STRUCTURES DESIGN BULLETIN C11-08

SUBJECT: Implementation of new Design Standards, Design Guidelines and Construction Specifications for Polymeric Bridge Fender Systems

This bulletin implements new requirements for Bridge Fender Systems.

Design Standards Indexes 21900, 21910, 21920 and 21930 have been removed and replaced in the July 2011 Interims with the drawings as shown in Attachment A as listed below.

Interim Date: 07/01/11
 Sheet No.: 3 of 7
 Index No.: **21930**

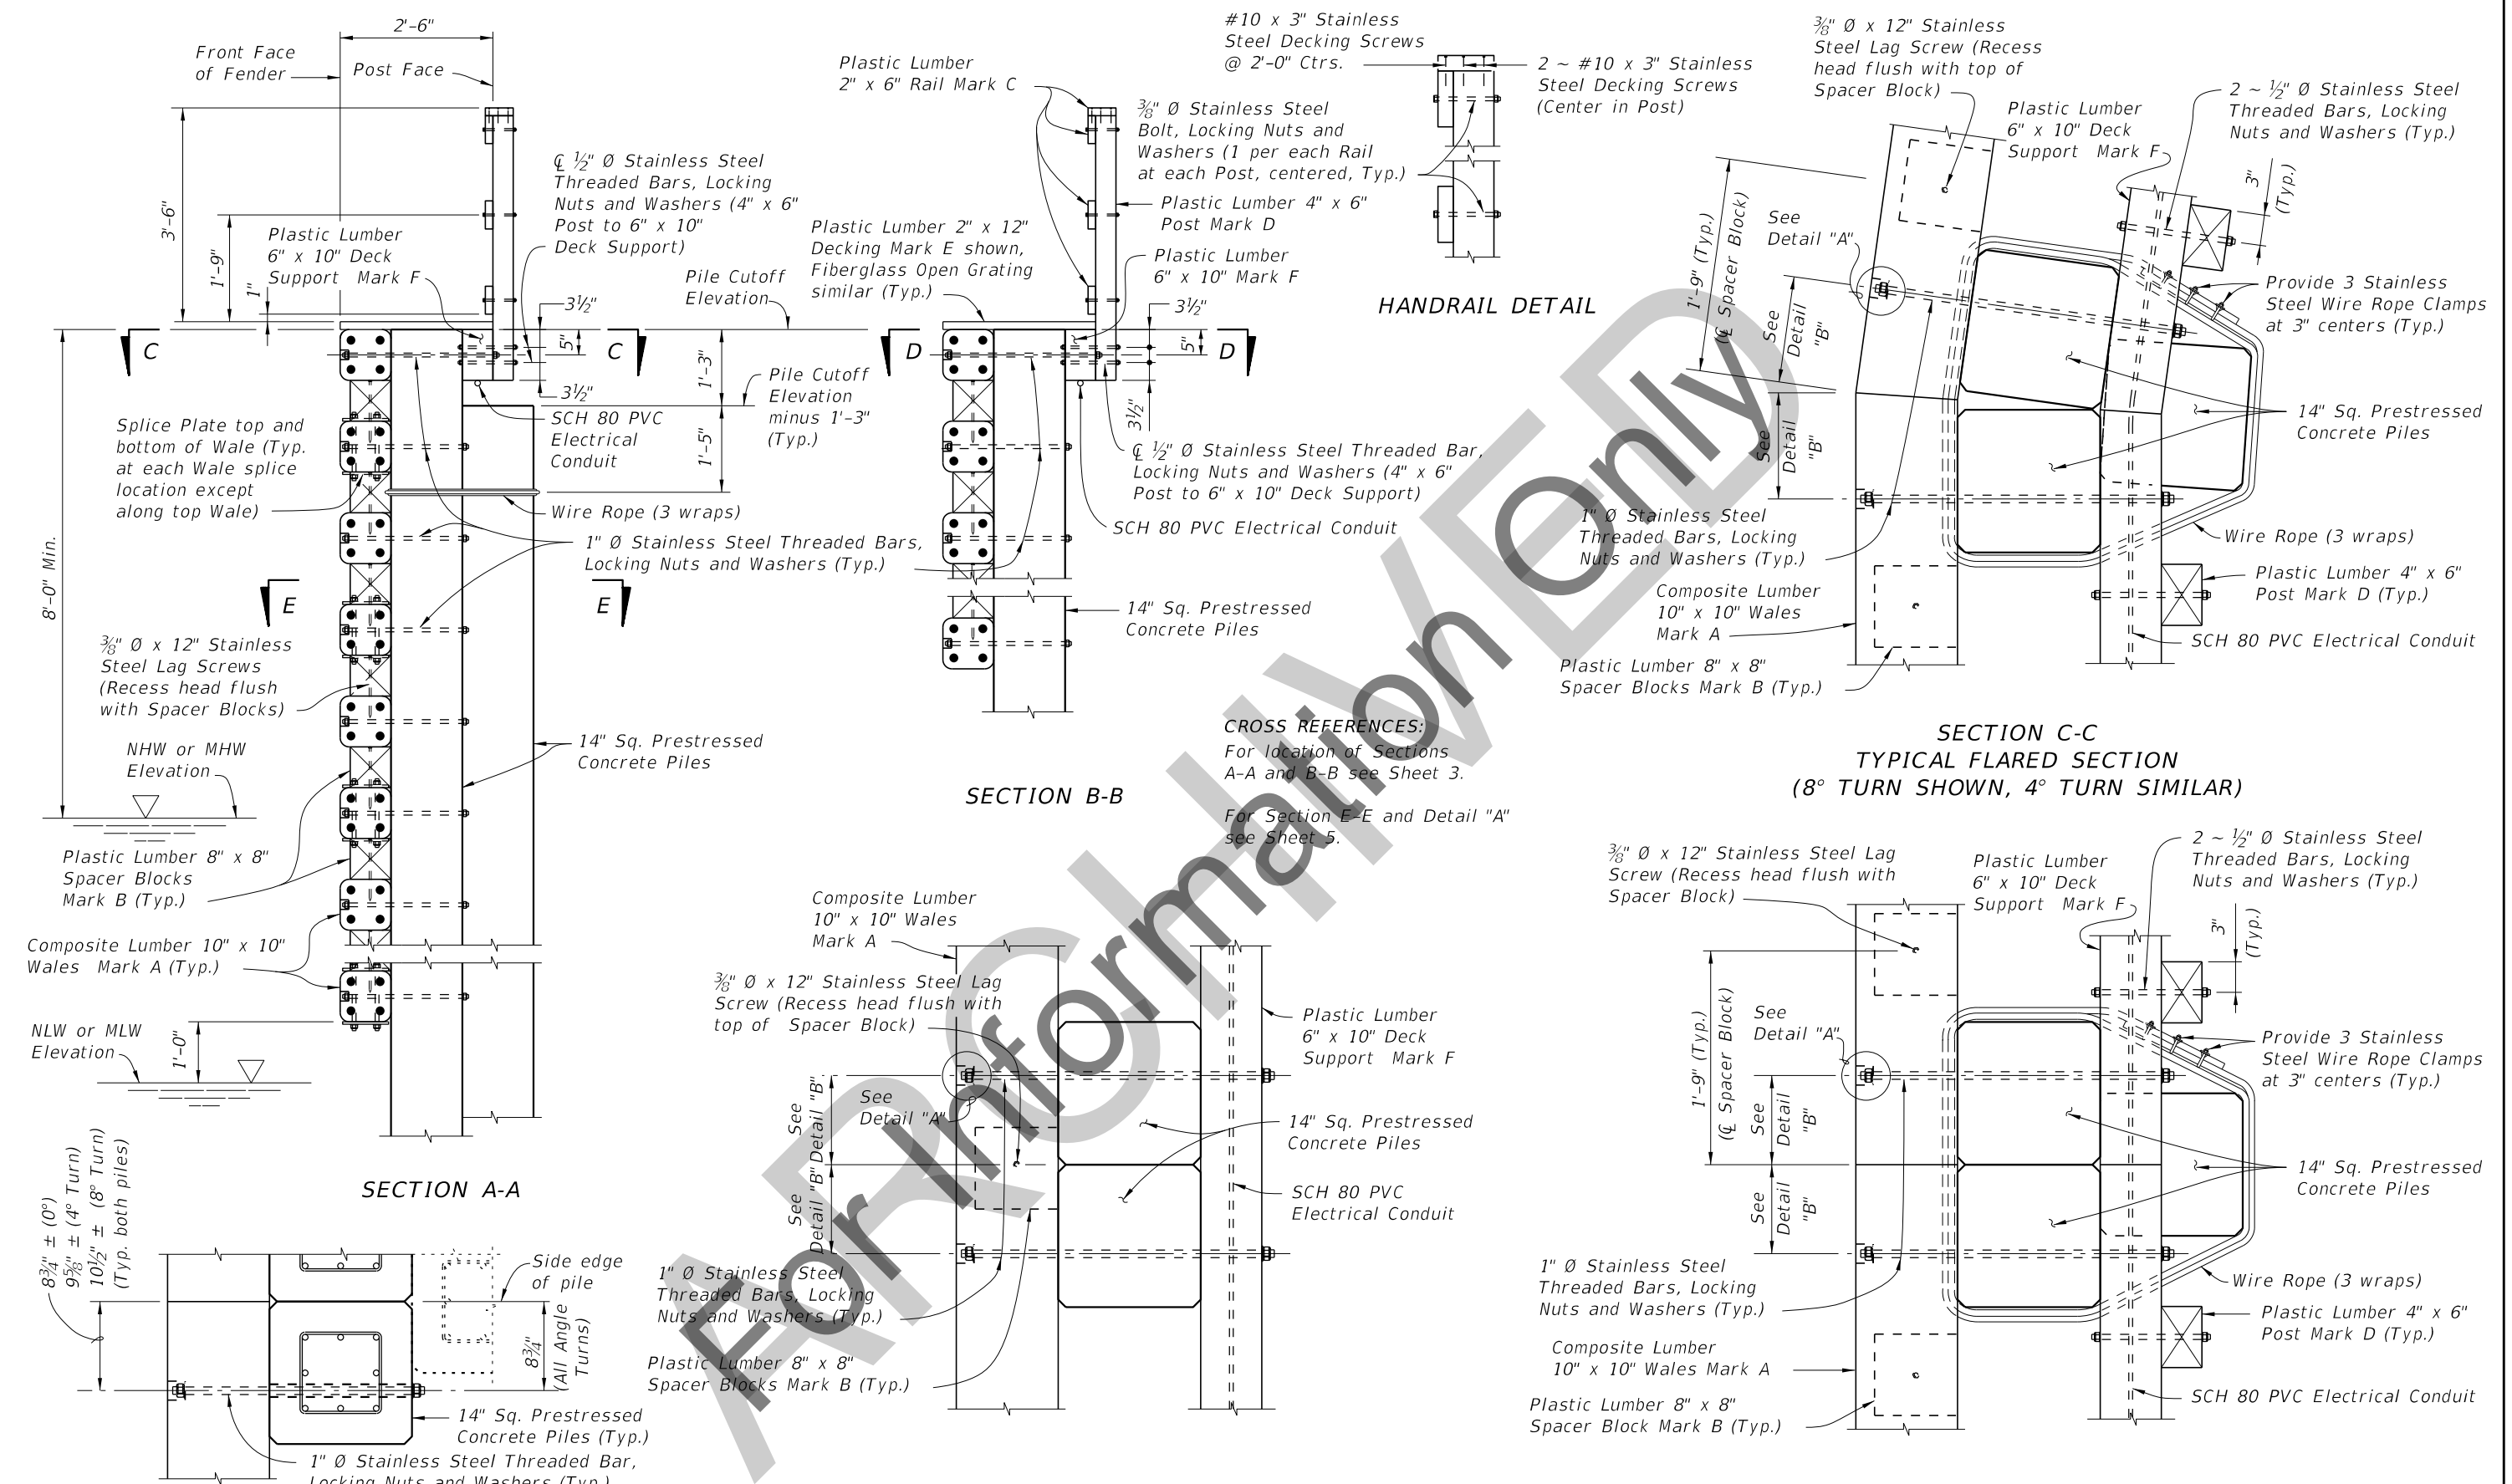
REVISIONS			
DATE	BY	DESCRIPTION	
07/01/11	GJM	Changed Title and Cross References; Changed bolt configuration for connection of Mark D to Mark F.

Interim Date: 07/01/11
 Sheet No.: 4 of 7
 Index No.: **21930**

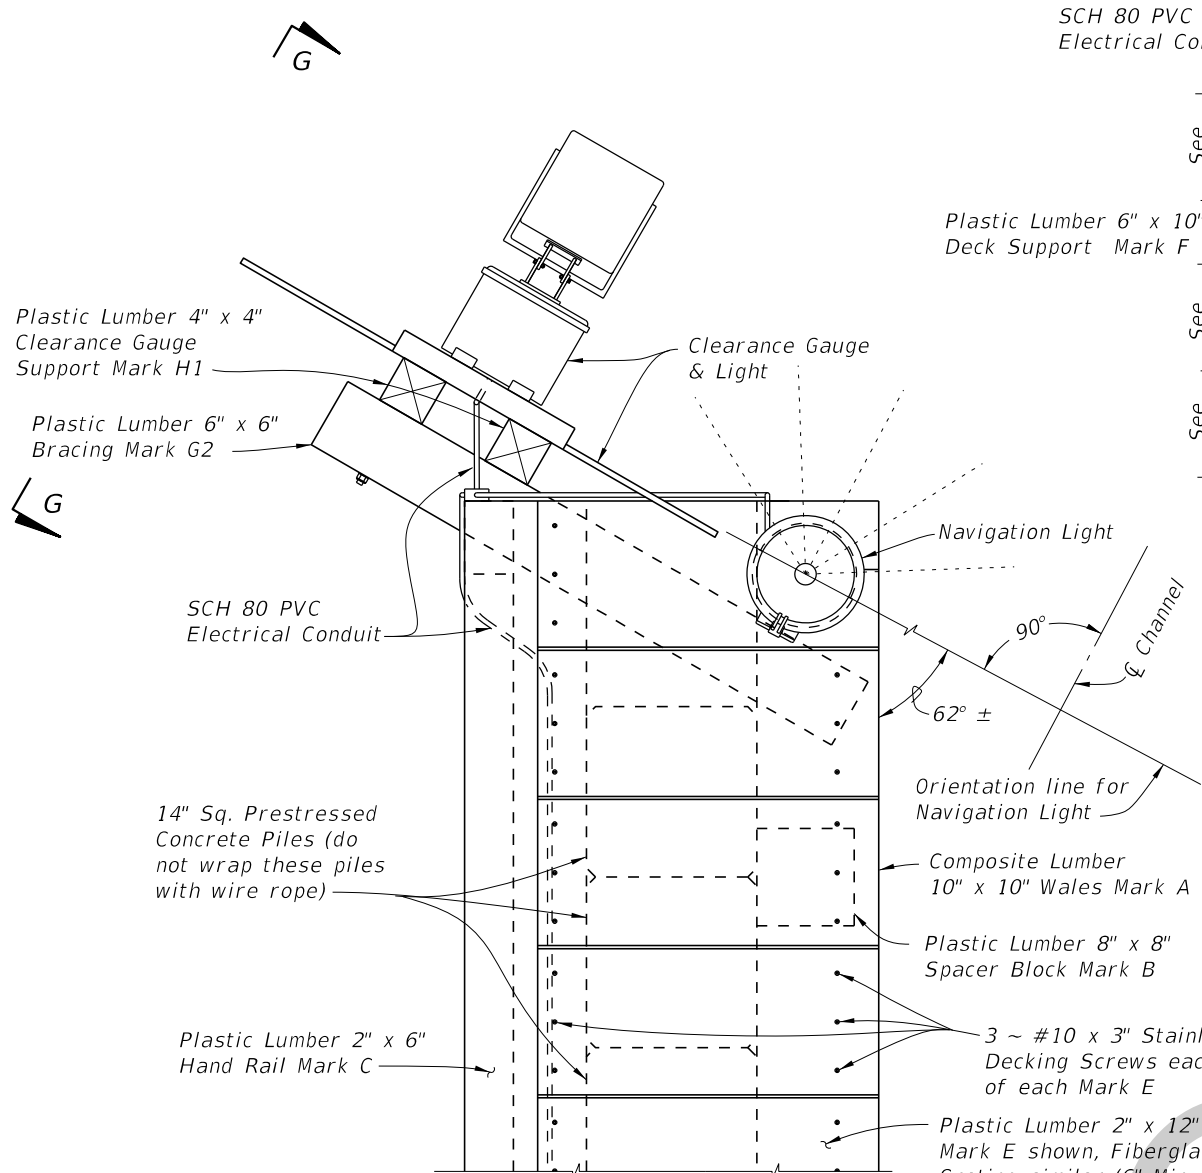
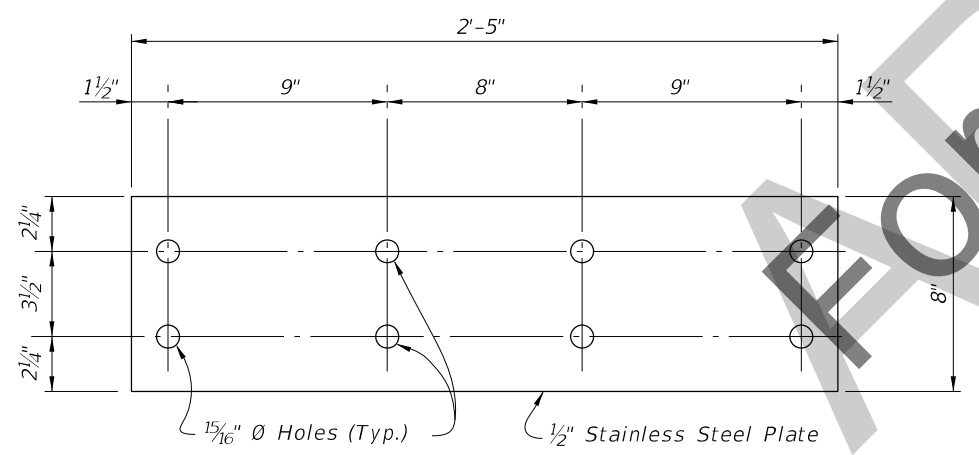
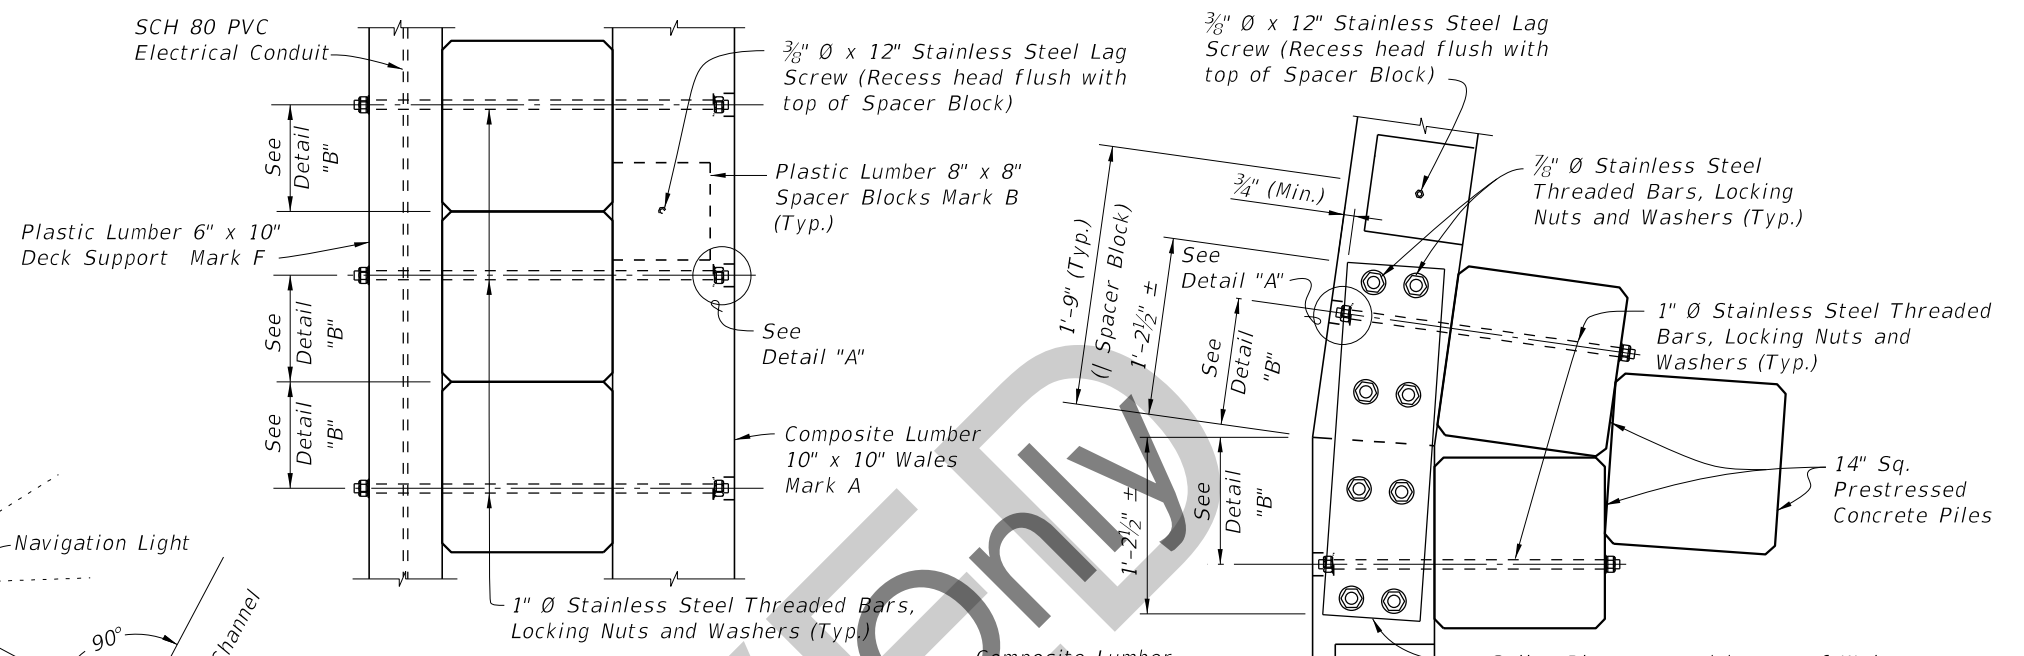
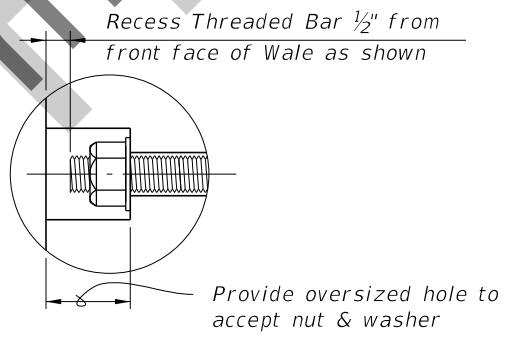
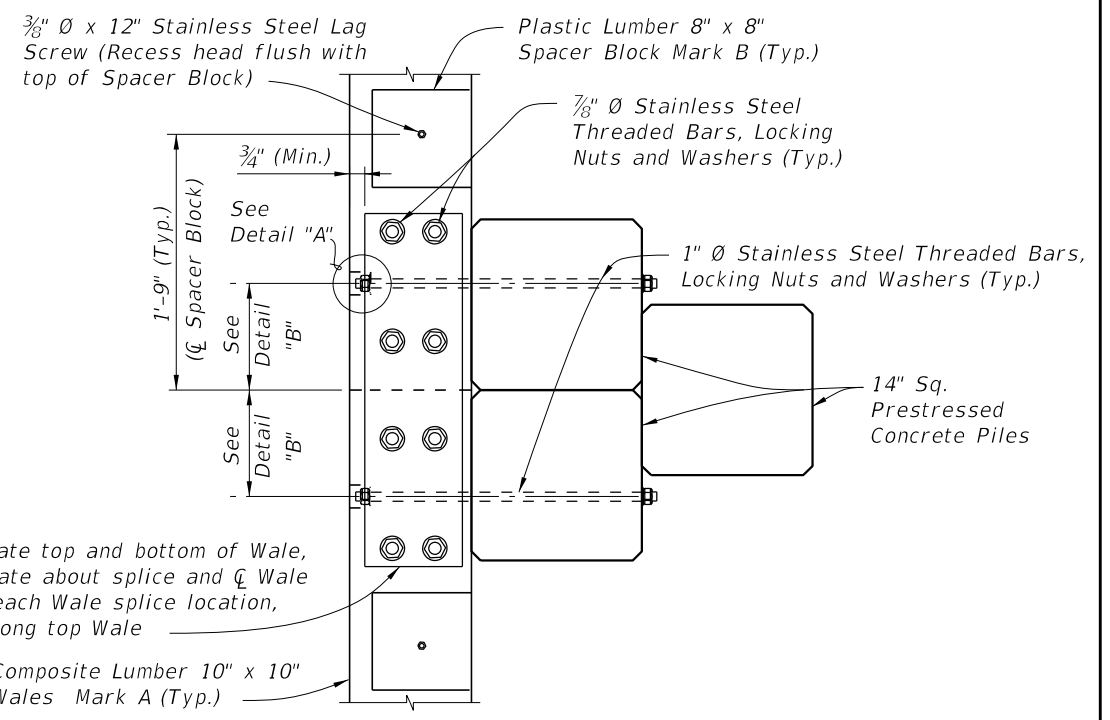
REVISIONS					
DATE	BY	DESCRIPTION	DATE	BY	DESCRIPTION
07/01/11	GJM	Changed Title and Cross References; Changed splice plate dimensions.
